**STAFF REPORT
KETCHUM PLANNING AND ZONING COMMISSION
SPECIAL MEETING OF MARCH 31, 2025**

PROJECT: 140 & 180 N Leadville Ave ARCH Affordable Housing Project

FILE NUMBER: P25-006

APPLICATION: Pre-Application Design Review

Figure 4: Flat Facades

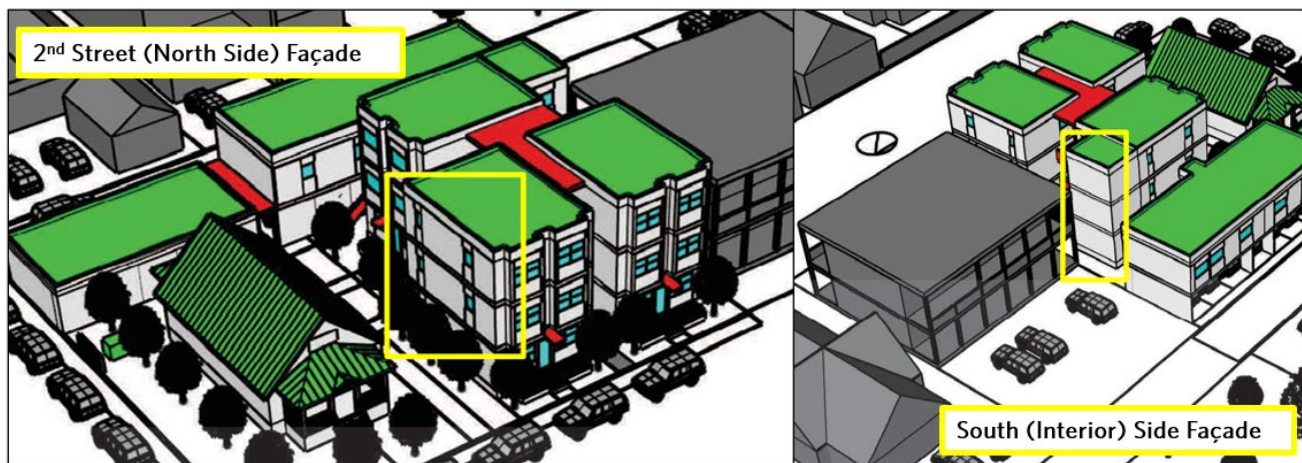
Pursuant to KMC §17.96.060.F.5, building walls shall provide undulation and relief to reduce the appearance of bulk and flatness. The three new three-story residential buildings are detached and connected by a covered external staircase. Staff believes this detached design provides relief to the mass of the three new residential buildings. IN addition, the façade design includes exterior material differentiation that provides visual relief. The front facades of the buildings include dark black/gray horizontal lap siding on the ground floor that is broken up by paned windows. The upper levels are comprised of smooth stucco that will be painted a natural beige color. The stucco is broken up by paned windows and black/dark gray board and batten vertical siding.

While Staff appreciates the visual interest provided by the exterior material differentiation, color contrast between the dark black/gray siding and lighter beige stucco, and paned windows, staff believes certain facades identified in Figure 4 appear flat and monotonous due to the height and length of certain portions of undifferentiated blank surfaces. Staff recommends the applicant consider modifications to reduce the appearance of bulk and flatness and provide more light, shadow, and texture to the façade design. In addition, staff recommends the applicant consider

providing decks or balconies/Juliet balconies for the upper-level apartments to help animate the façade and provide private open space for tenants.

A.2

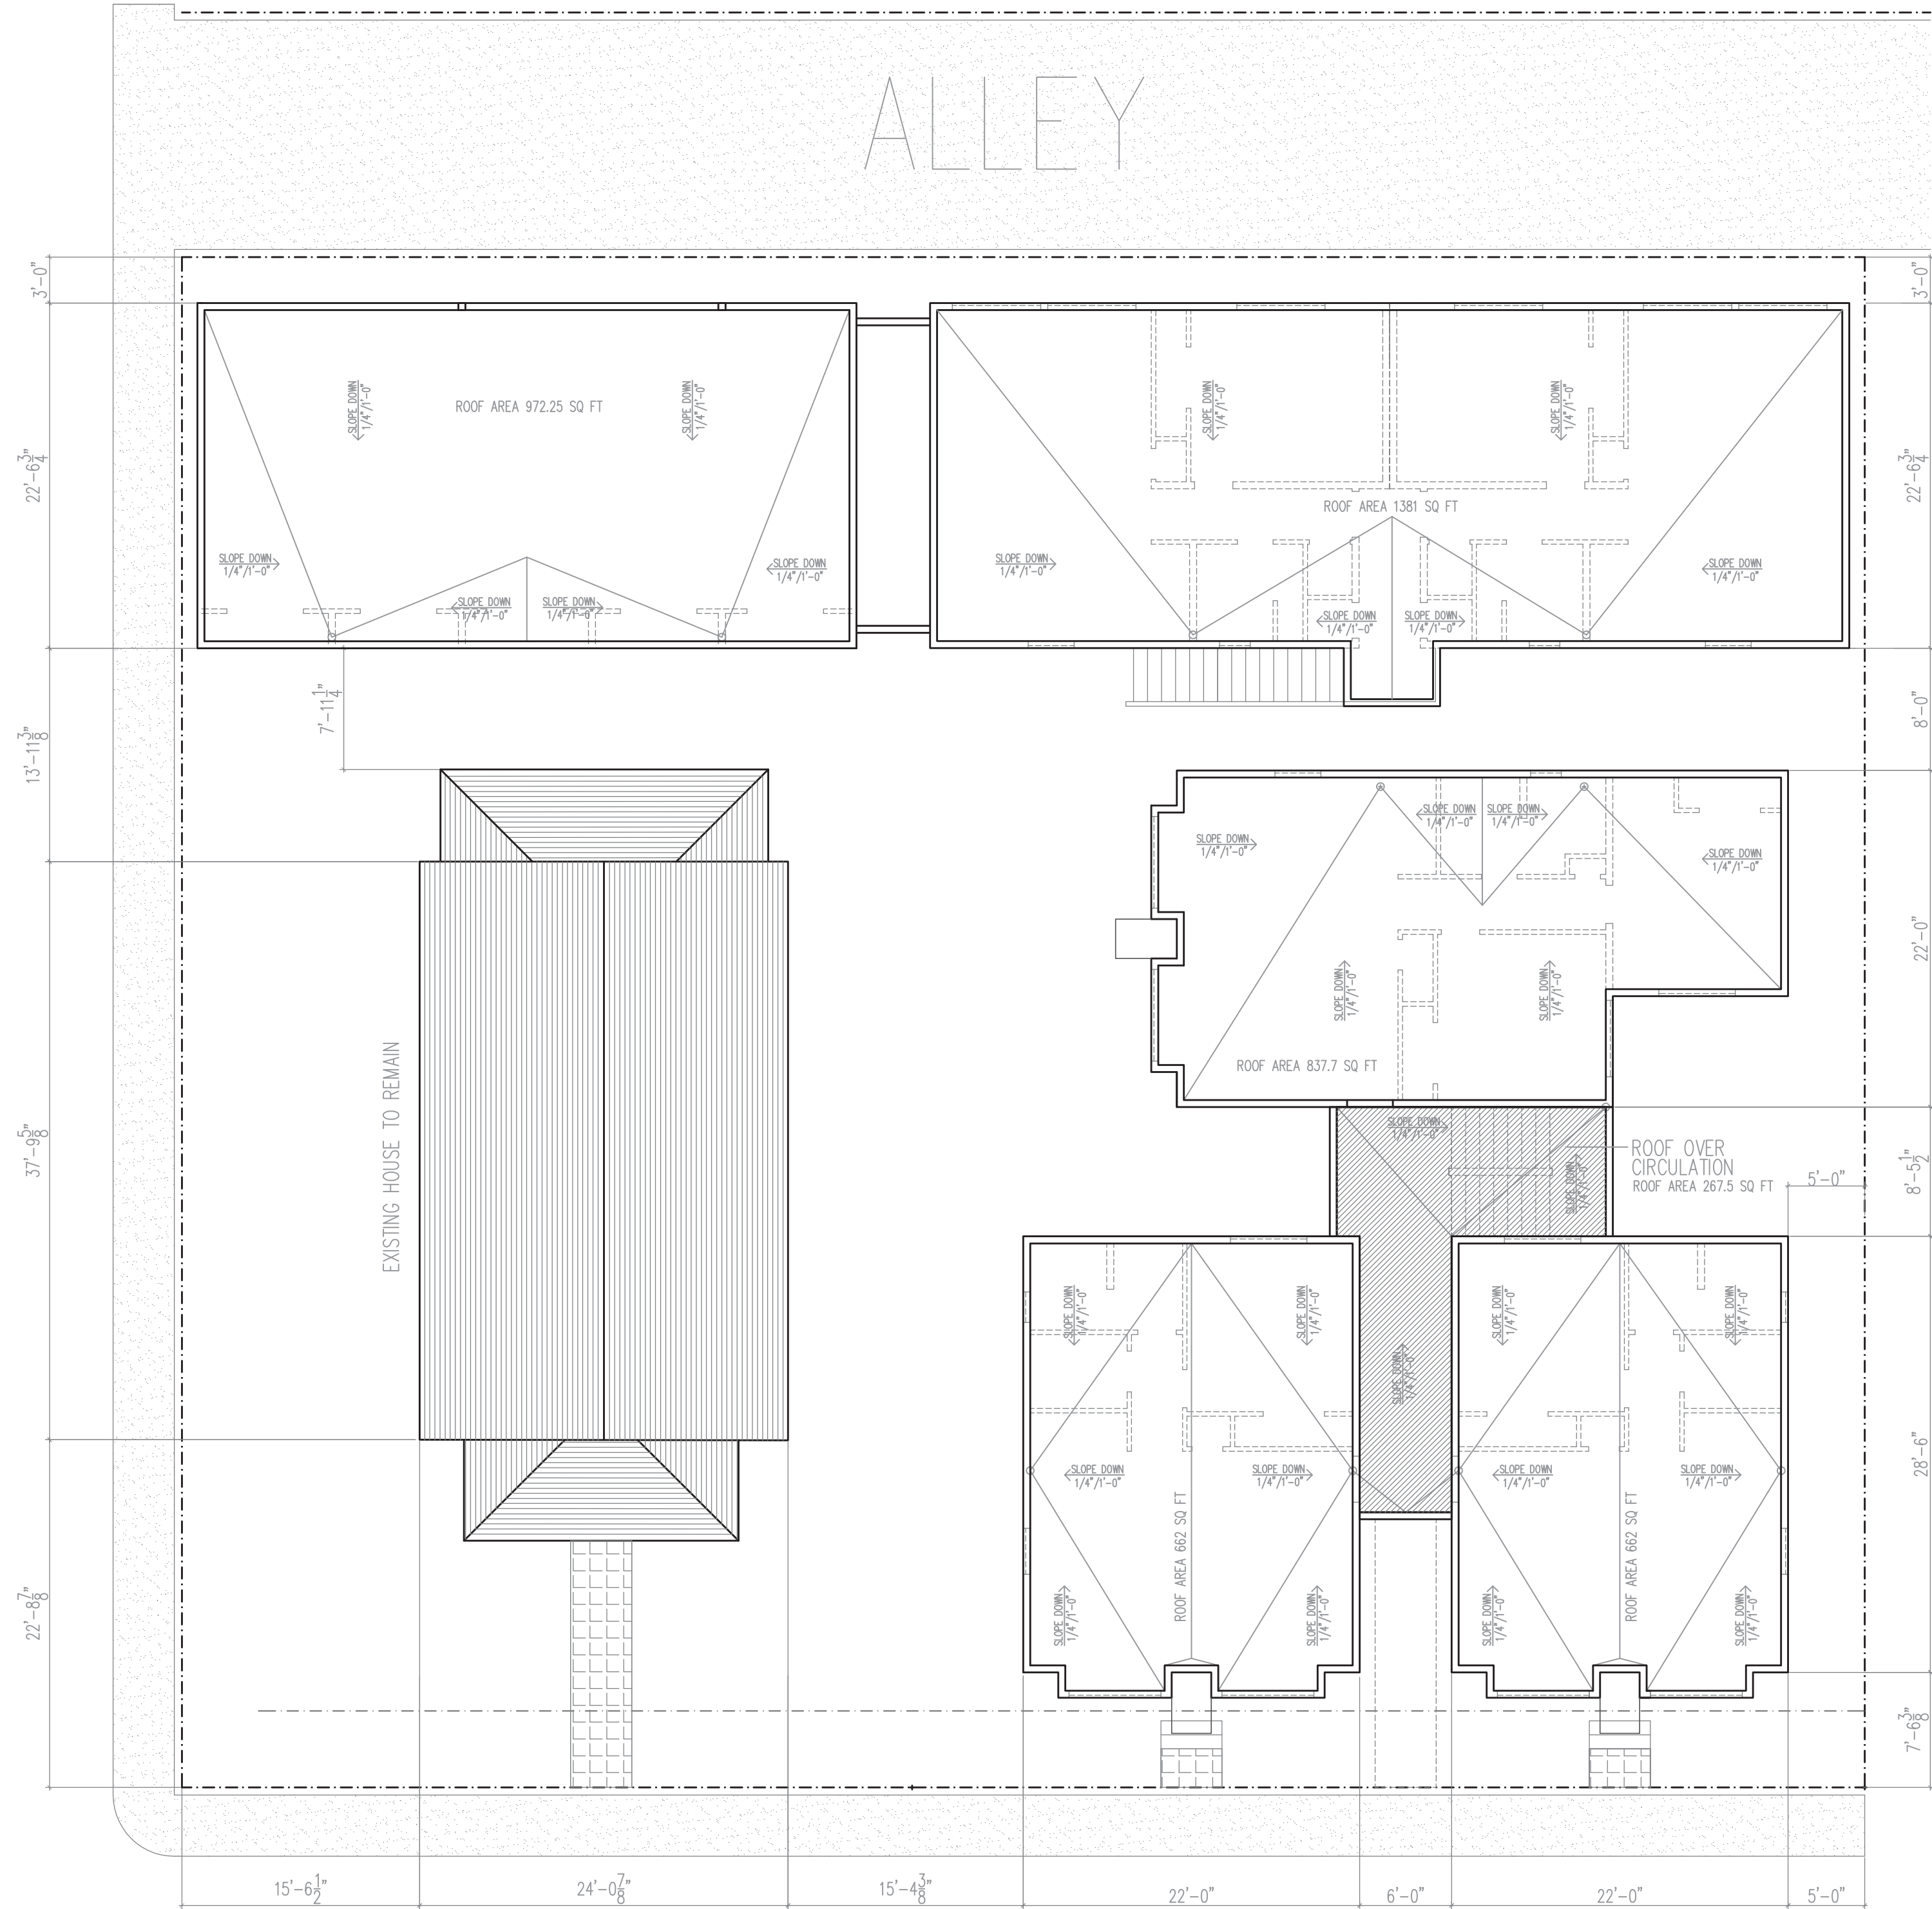
Pursuant to KMC §17.96.070.C2, “Roof and ground mounted mechanical and electrical equipment shall be fully screened from public view. Screening shall be compatible with the overall building design.” As shown on sheet A.2 of the project plans, a new transformer is proposed to be installed

by the 2nd Street sidewalk. While new transformers are encouraged to be located along the alley, the proposed siting of the new transformer accommodates more space for off-street parking. As the proposed transformer is surrounded by an open space buffer on all sides, staff believes there is sufficient area to fully screen the transformer from public view along the sidewalk.
